ADDENDUM NO. 30 - Contract Drawing C.1

**CONTRACT 876-HP
GEOMEMBRANE CAPPING AND
GAS COLLECTION SYSTEM
PELHAM BAY LANDFILL REMEDIATION
BOROUGH OF THE BRONX
NEW YORK**

Bid Form - Contract No. 876-HP - Revised 5/25/94

TYPICAL HDPE/CONCRETE ATTACHMENT DETAIL FOR BAFFLED OUTLETS
NOT TO SCALE

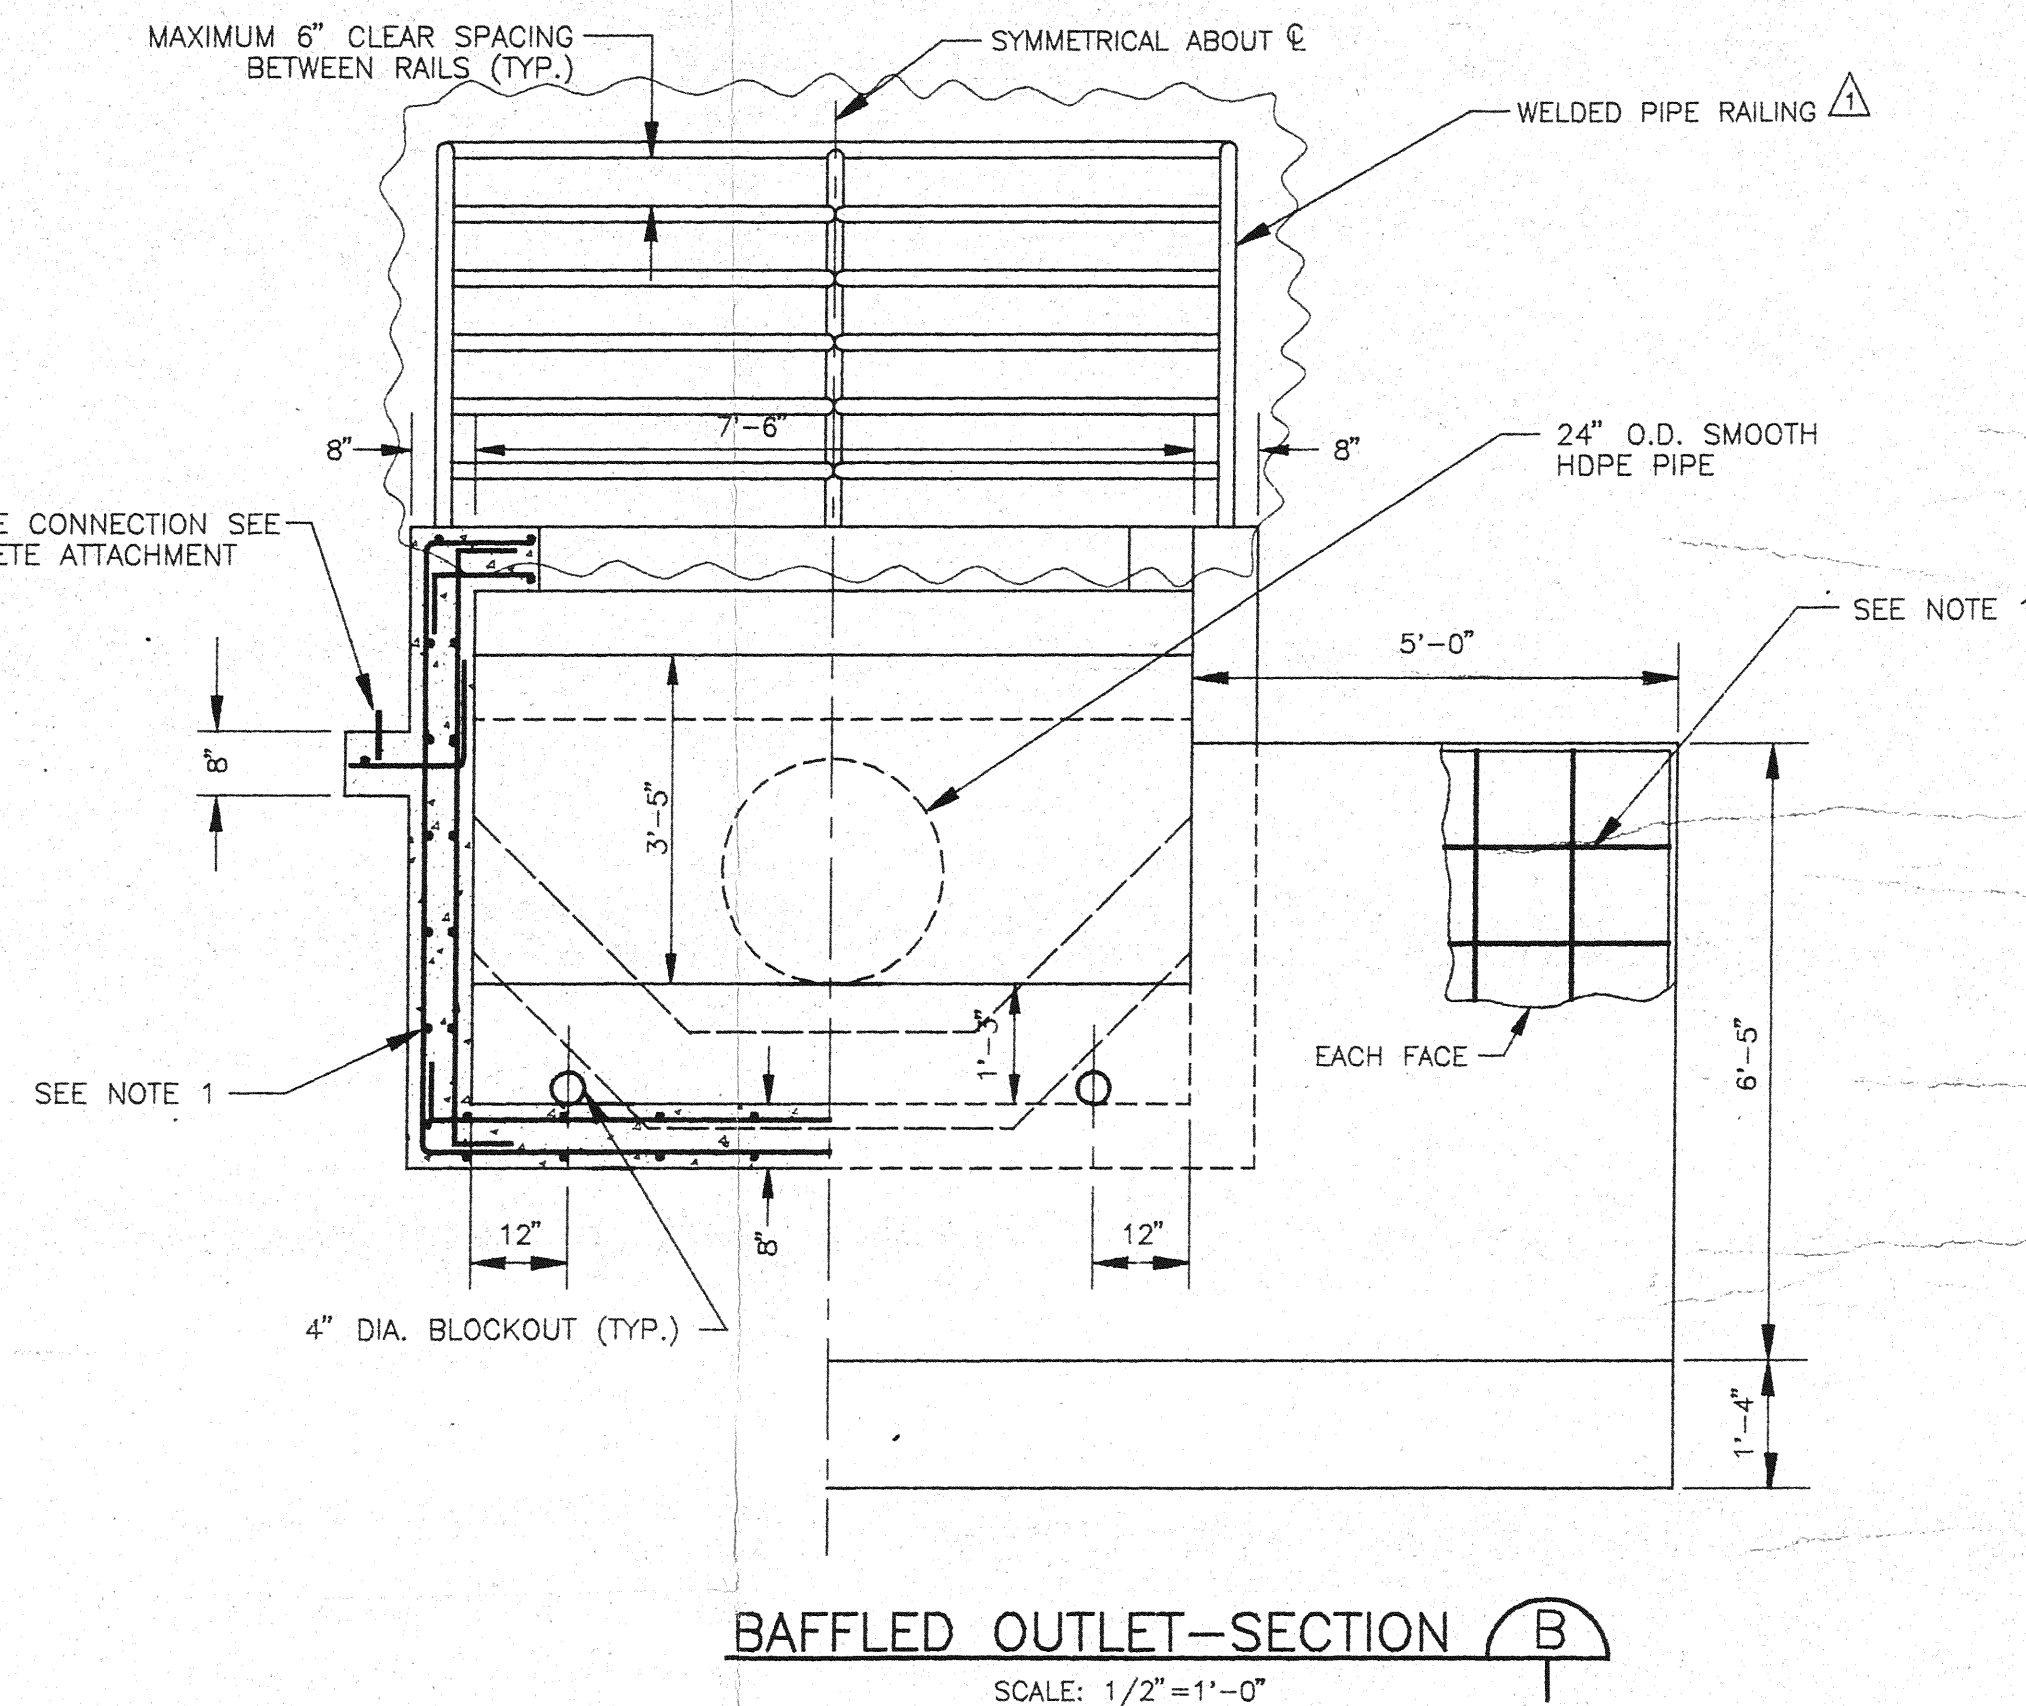
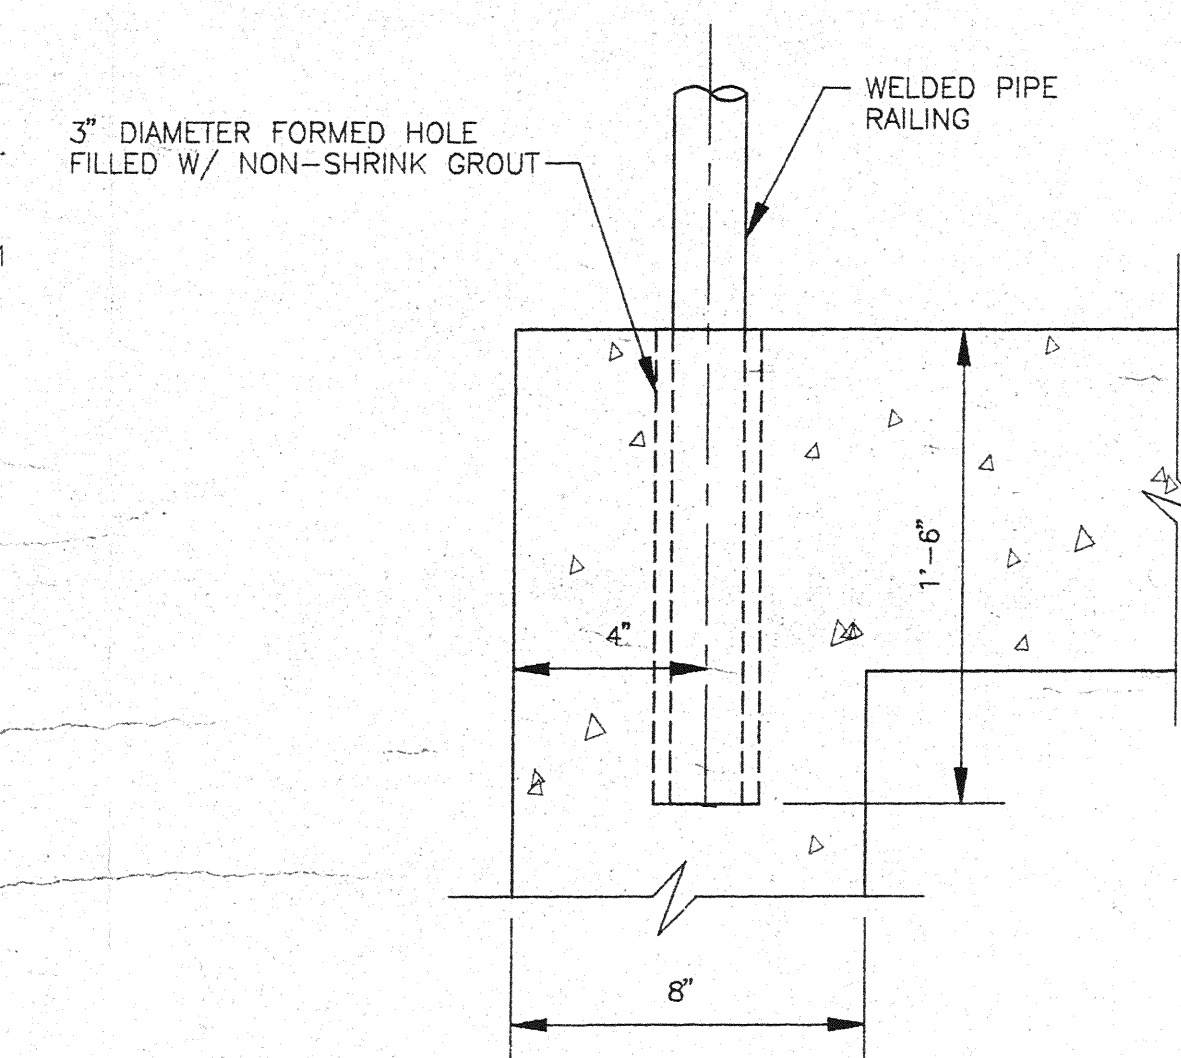
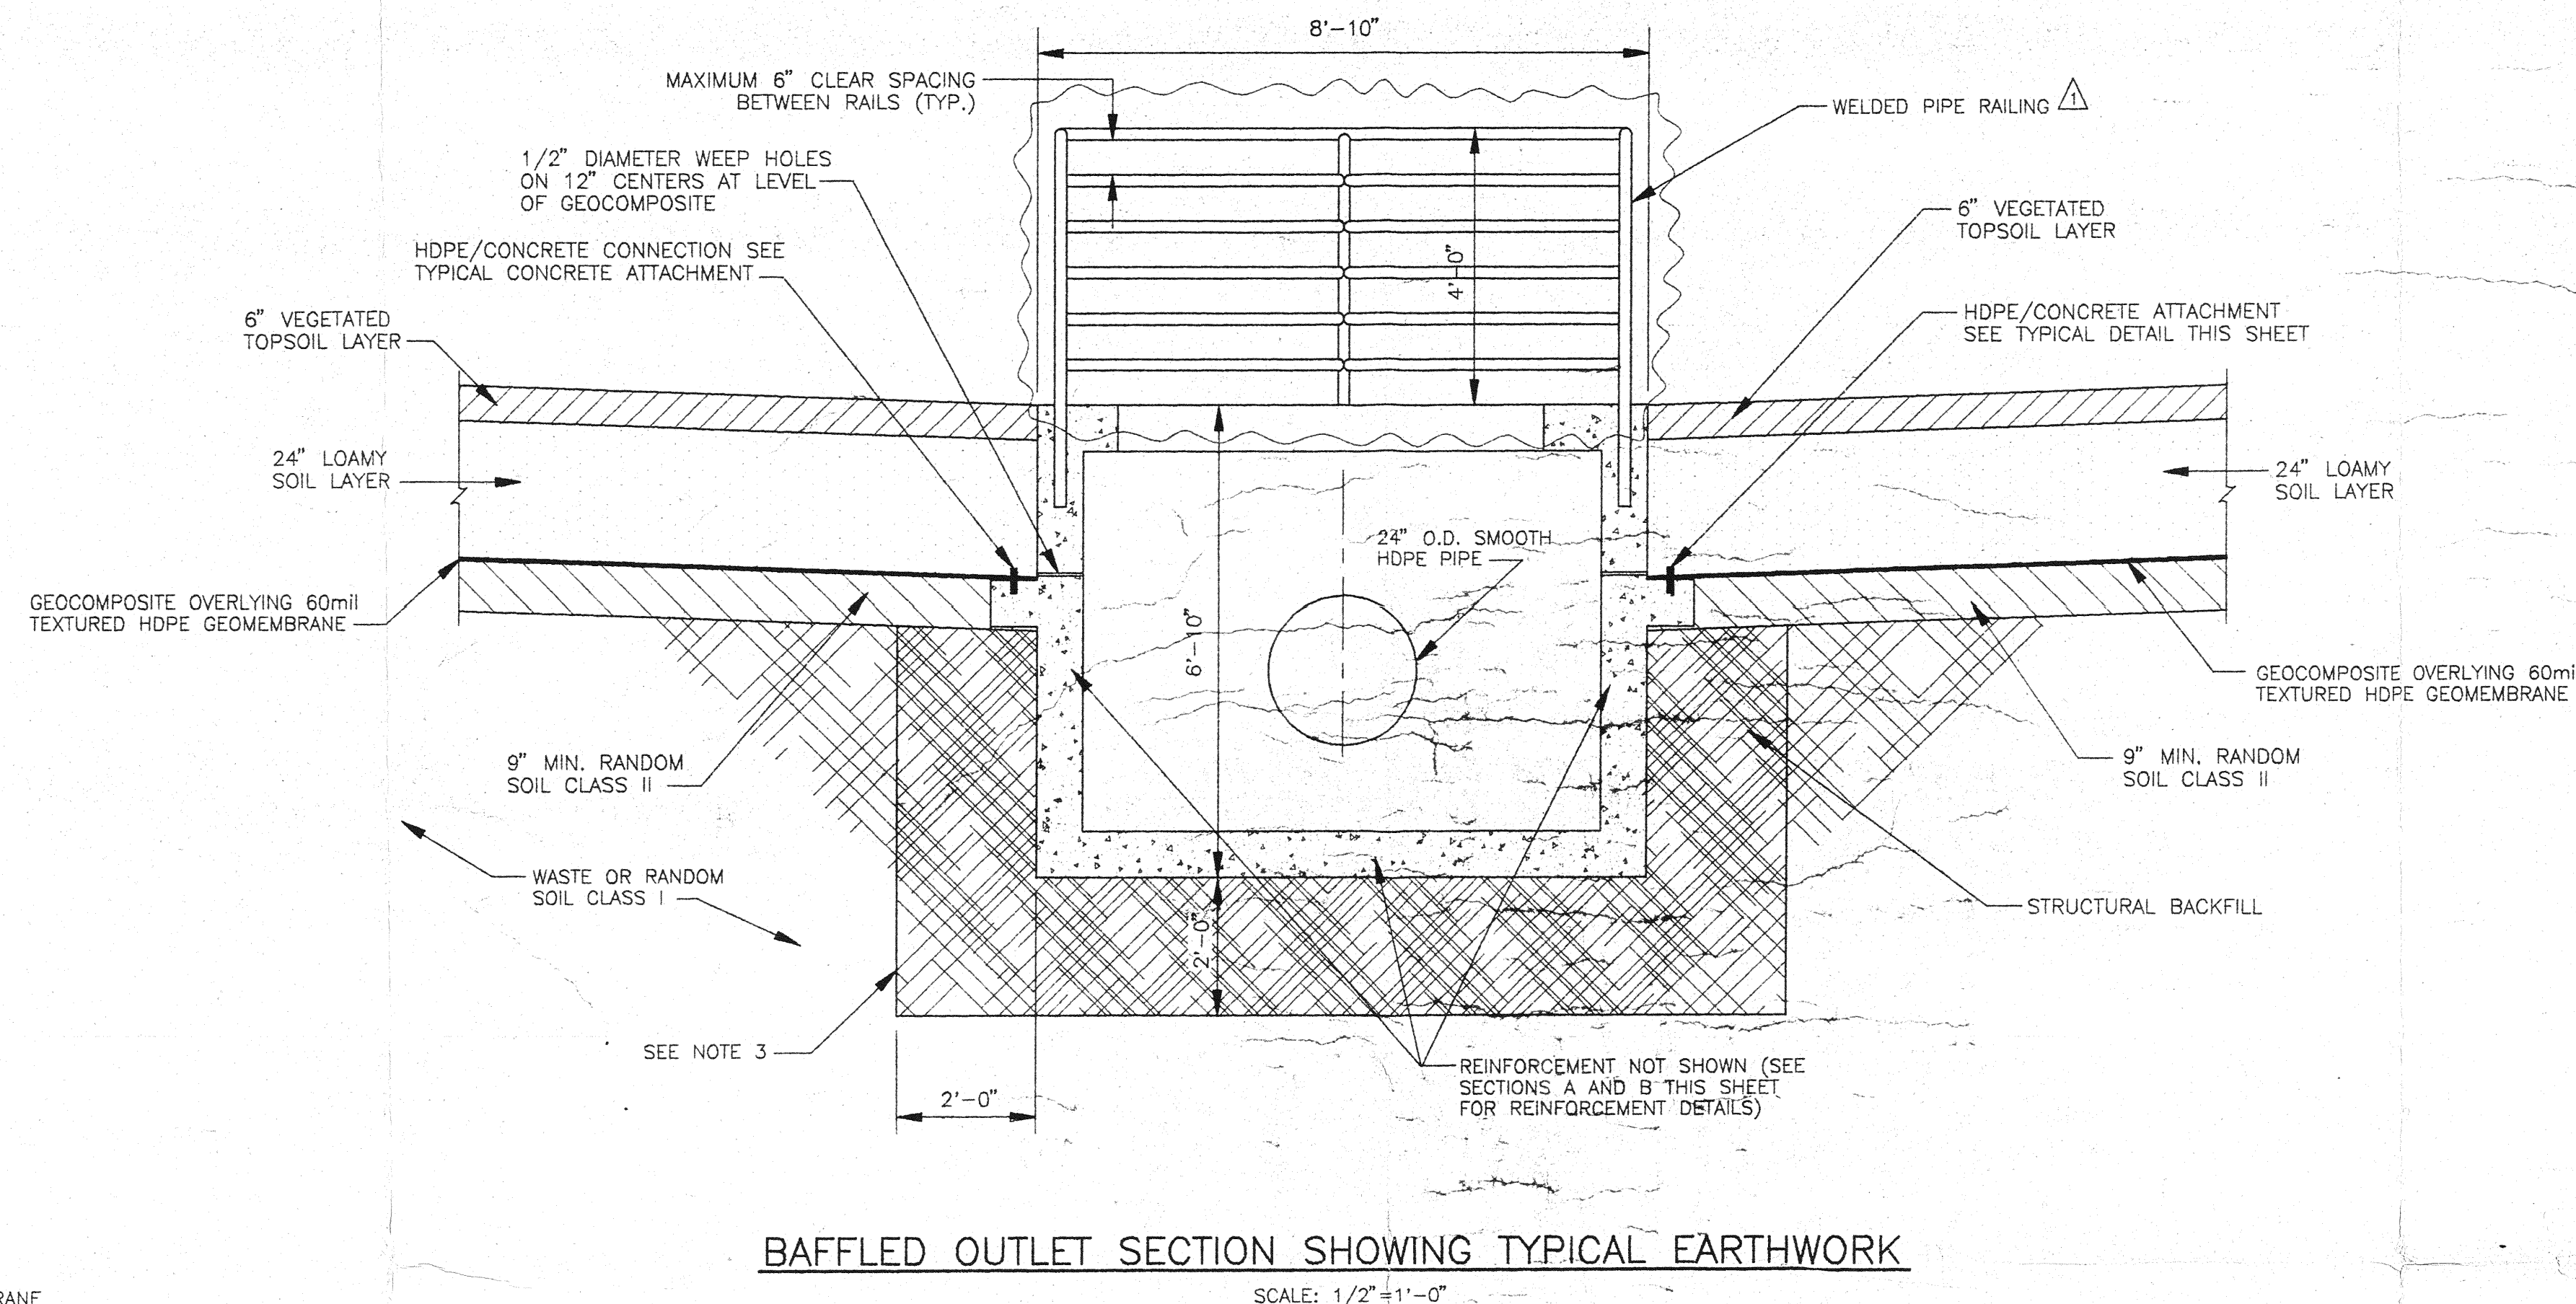
1. Replace Contract Drawing C.11 with revised version (Drawing C.11R1), attached at the end of this package. Revisions made to this Drawing are described below:
 - A. New details (mainly spacing) for the Welded Pipe Railing.
 - B. Revisions to "BAFFLED OUTLET - SECTION A".

Refer to sheet 12/28, BAFFLED OUTLET SECTION SHOWING TYPICAL EARTHWORK: Note 3 is referenced in this section. Reference is made to "STRUCTURAL BACKFILL" on the right side of the section. There is no item for structural backfill. Please clarify and/or define what item(s) the payment limit lines represent.

Refer to sheet 12/28, BAFFLED OUTLET: On the plan, upper left this sheet, there is a note with regard to the handrail to see note 4. Note 4 refers to rip rap. Further, nowhere can we find the size of the handrail members. Please clarify.

Structural Backfill is incidental to the "**Outlet Structure**" work defined in item No. 120 of the revised Bid Form presented in Addendum No. 64 as is with other structure items. Note 3 on Drawing C.11 refers to the bid items, and structural excavation and structural backfill are incidental to that item.

Refer to Addendum No. 34 for revised drawing C.11R1. For the size of the handrails, see answer to question 15.
